# **EXHIBIT B**

## **SWEPCO'S RESPONSE TO COMMENTS and ADEQ'S RESPONSIVE SUMMARY**

**IN RE: REQUEST BY THE SOUTHWESTERN )  
ELECTRIC POWER COMPANY )  
TO INITIATE RULEMAKING TO ) DOCKET NO. 14-007-R  
AMEND REGULATION NO. 2 )**

**ARKANSAS DEPARTMENT OF ENVIRONMENTAL QUALITY'S  
RESPONSIVE SUMMARY FORTHIRD PARTY RULEMAKING TO AMEND  
REGULATION NO. 2**

FIGURE J.1 LA-QUAL SCHEMATIC DIAGRAM

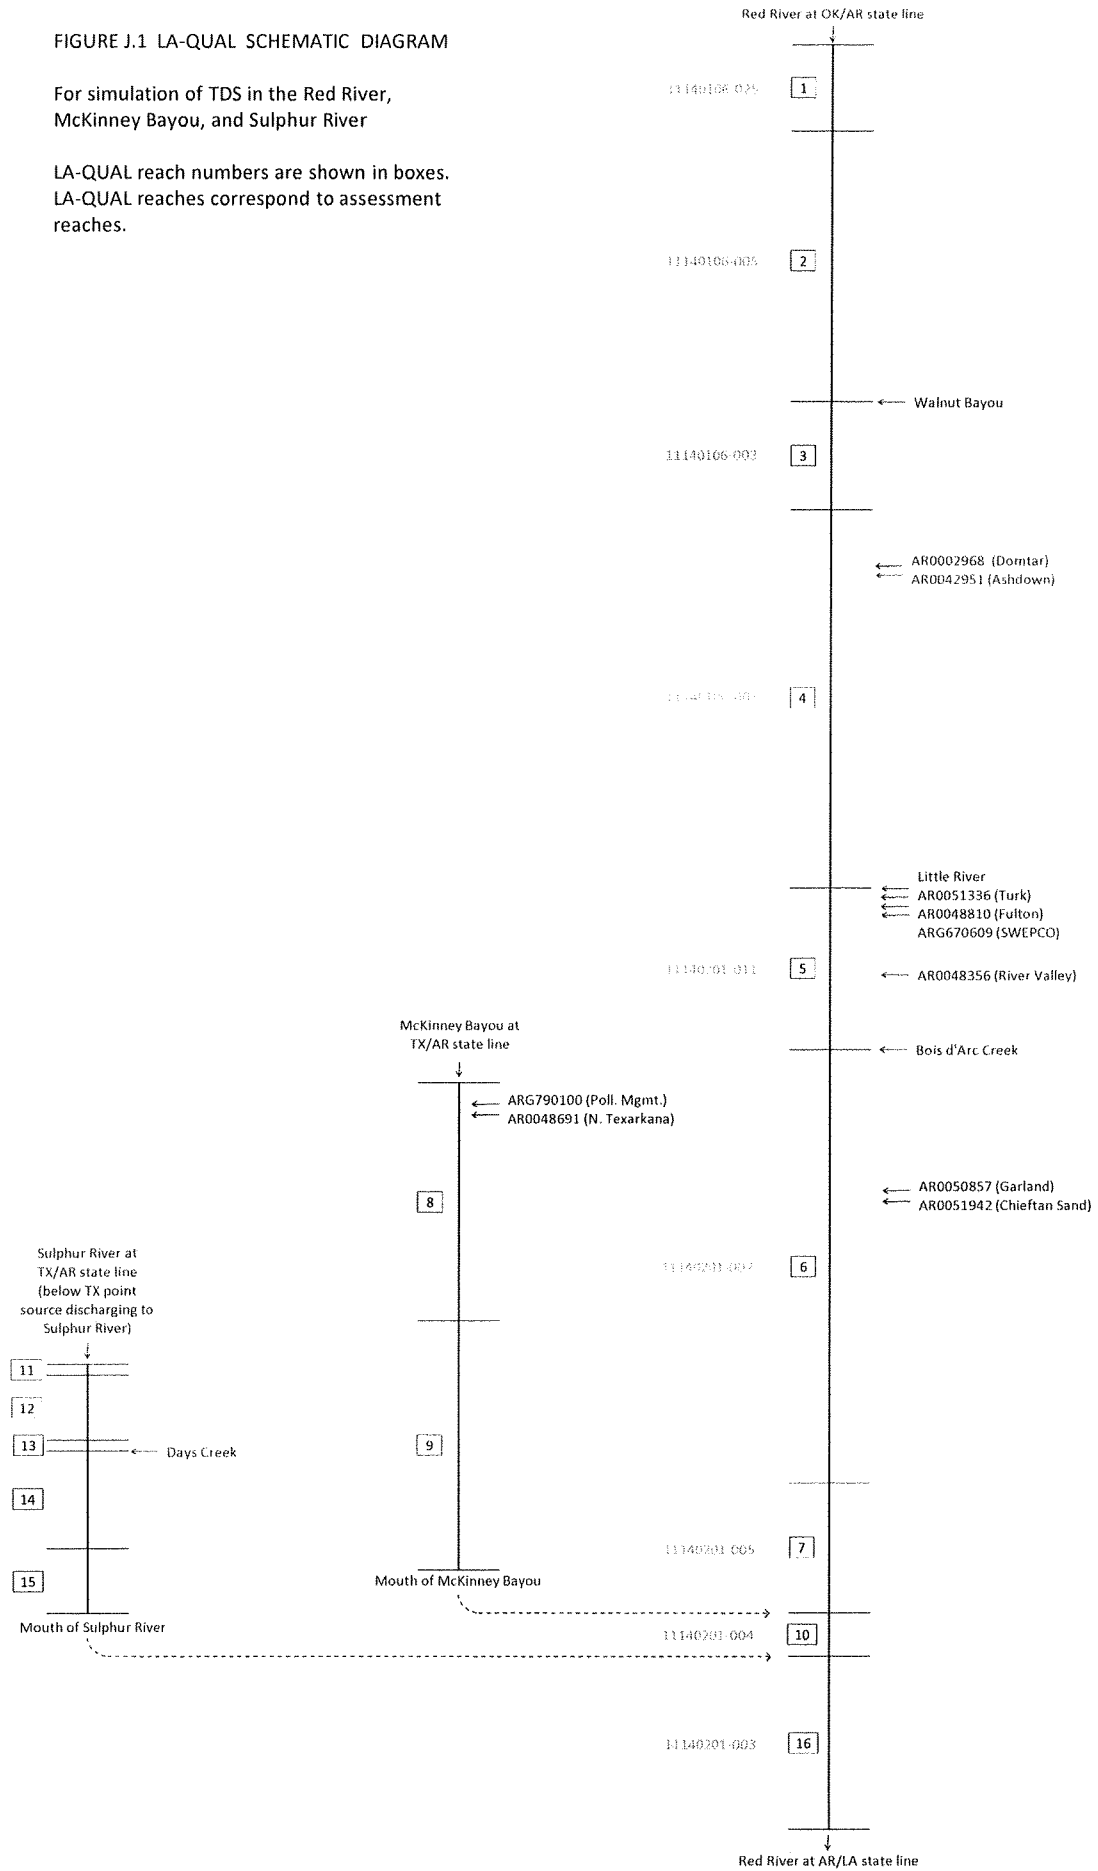
In Figure J.1, IP proposed removing “TX0000167 (Int’l Paper)” from the Sulphur River schematic and beginning the schematic “below TX point source discharging to Sulphur River” thus beginning the model downstream of IP. It is not inaccurate to include IP in the model used to calculate instream water quality criteria; this revision is not necessary.
